ADDENDUM # 1
Systemic Safety Project
PROJECT NUMBER
BID # 4538

The City of St. Charles is issuing this Addendum to the Systemic Safety Project Bid Documents. The purpose of the addendum are to separate out pavement repair work in the bid form, removed and added language in the Job Special Provisions (JSPs), added Crosswalk Illuminator and pilot light call out on detail sheet, and removed call outs on plan sheets. These modification affects the BID FORM, JSP-4.5, JSP-14.2, JSP-15.1, JSP-16.2.0.4, JSP-30.4, Detail Sheet, Quantity Sheet, and Plan Sheets 34 & 35. The revised bid information is as follows:

ST. CHARLES SYSTEMIC SAFETY
CITY OF ST. CHARLES, MISSOURI

CITY PROJECT #18STR29
STP-7302(671)

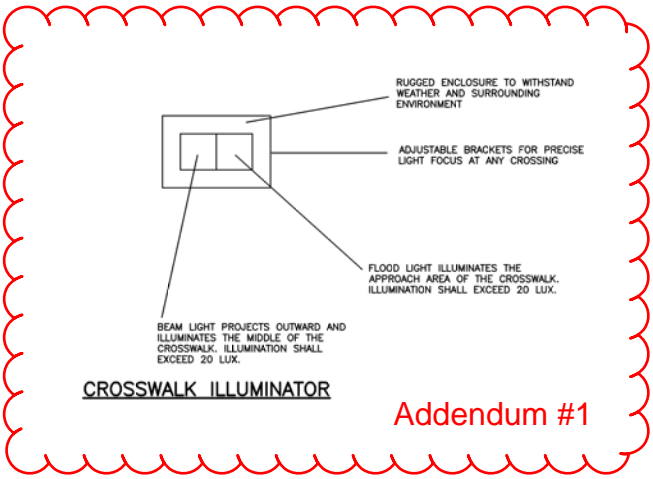
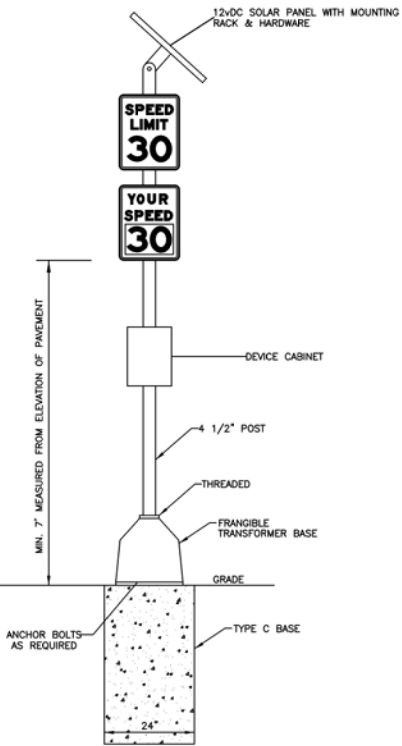
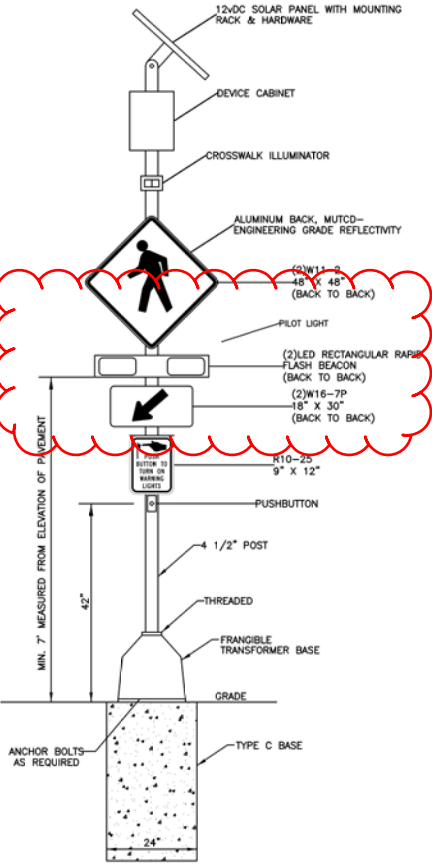
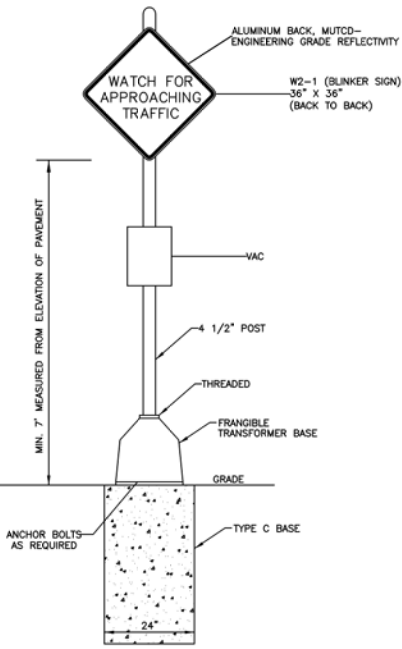
7. On the Plan Sheet #3 (detail sheet), a crosswalk illuminator detail and a call out for pilot light was added.
8. On the Plan Sheet #4 (summary of quantities), quantities were added under the column called Non-Participating Items as the following: Removal of Improvements – Pavement Repair Work, Concrete Pavement (8 in non-reinf) – Pavement Repair Work, and Epoxy Coated Tie Bars (drilled and installed) – Pavement Repair Work. Original quantities were reduced accordingly.

**PLAN SHEET
ELM ST & KEN DR**

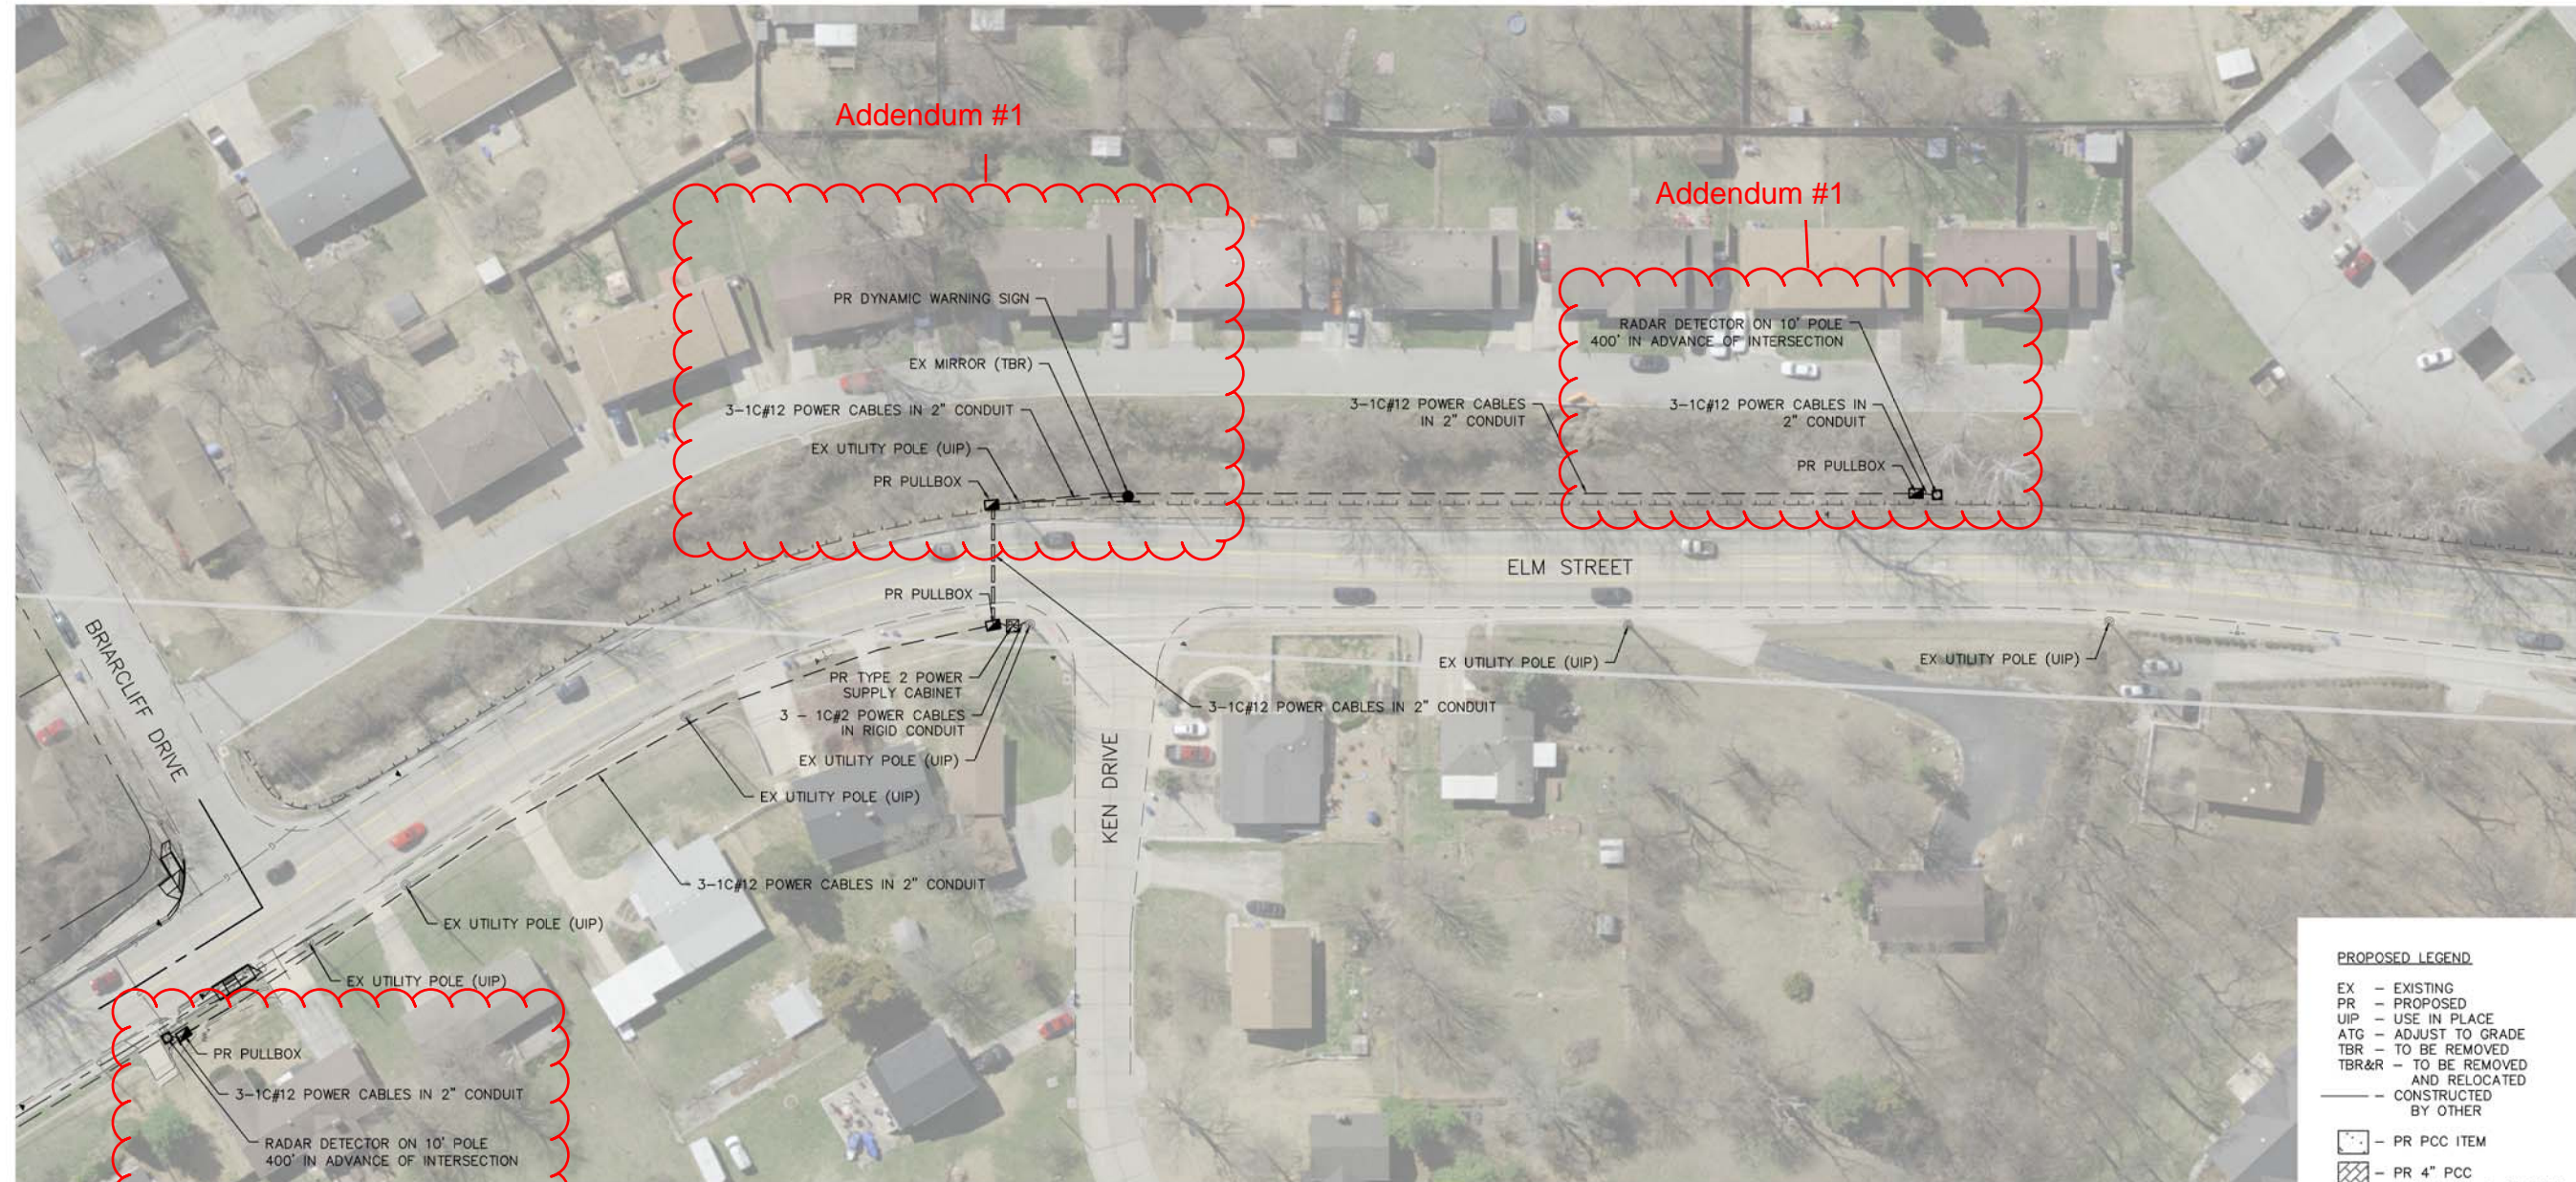
9. On Plan Sheet #34, all call outs stating Wireless Radio Unit were removed.

PLAN SHEET
ELM ST & SIGNAL HILL CT

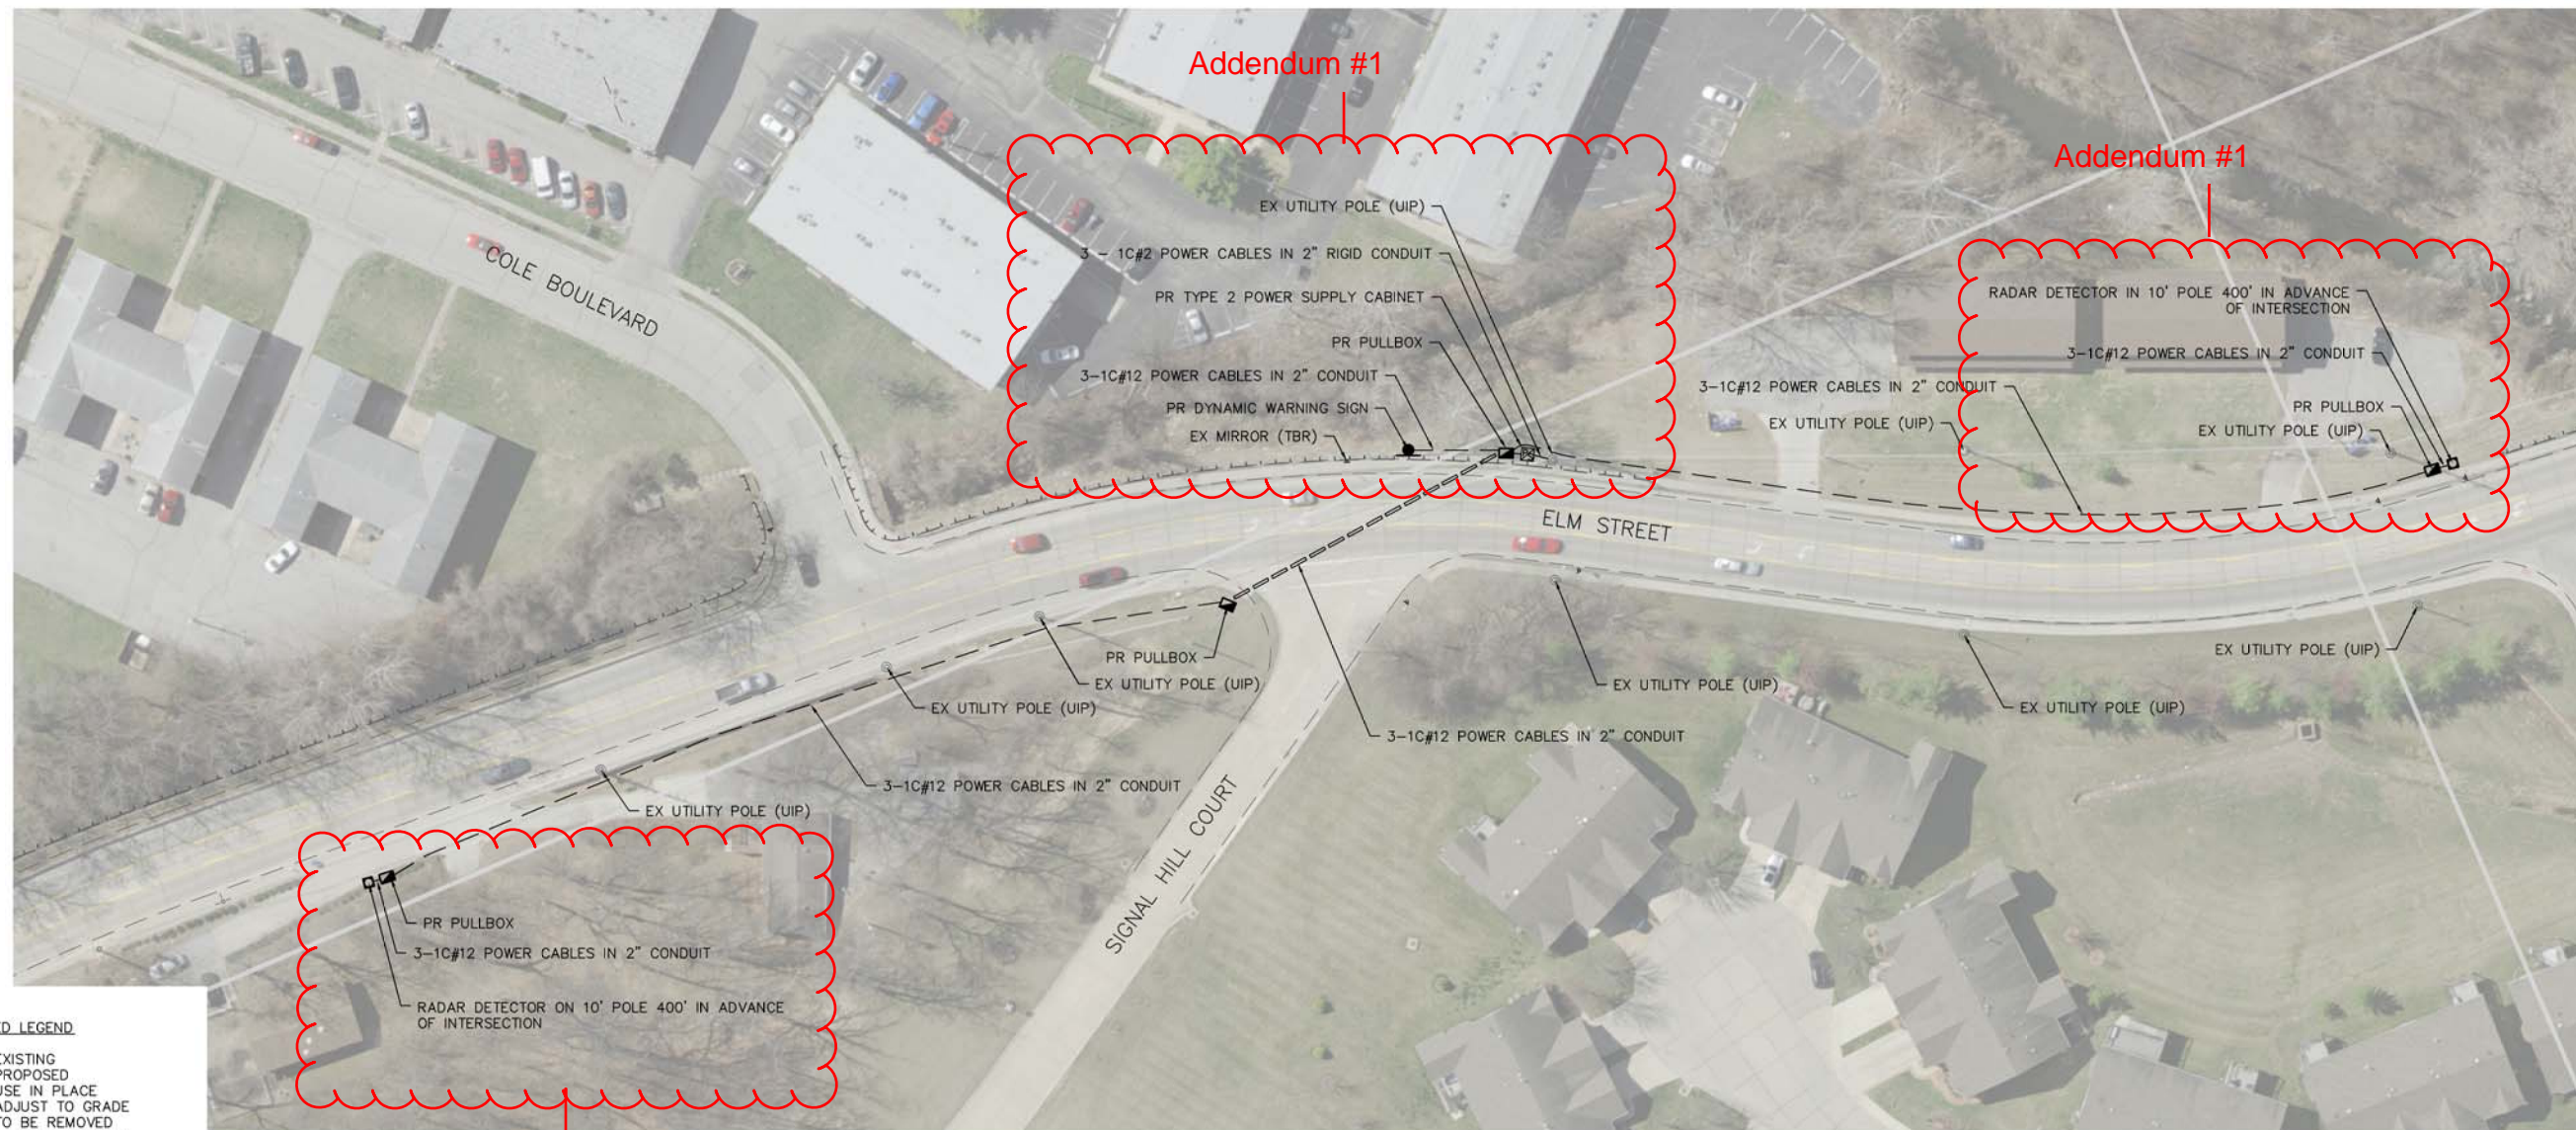
10. On Plan Sheet #35, all call outs stating Wireless Radio Unit were removed.
